PRODUCT BULLETIN

Bulletin No: PB408
Issue Date: 9-28-2017
Effective Date: 9-28-2017

Debris Screen for HAKKO FA-430 Duct Kit Nozzles

999-700

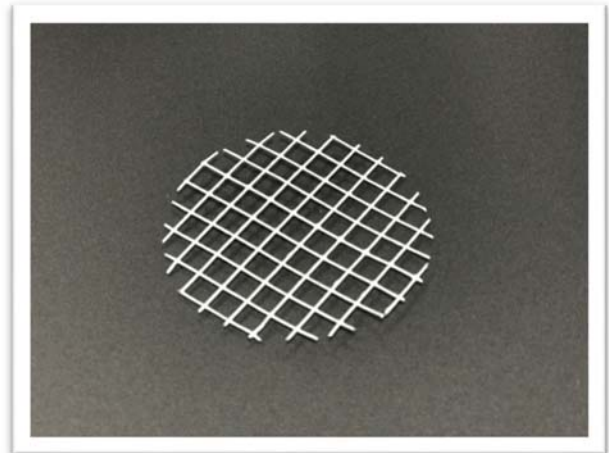
This new improved debris screen is made from a durable steel wire and has a longer service life compared to the standard netting (PN: B3625) that comes with the HAKKO FA-430 Duct Kits (PNs: C1571 and C1572).

The debris screen is easy to install inside the nozzle and does not affect the filtration performance of the HAKKO FA-430 Fume Extraction System.

Compatibility	Fits B3622 and B3623 Nozzles (Nozzle are part of C1571 and C1572 Duct Kits)
Material	Hot dipped galvanized steel wire – 23 AWG
Dimensions	Approx. 60 mm diameter x 1.1 mm thick
Weight	Approx. 2 g
ESD Safe	Yes
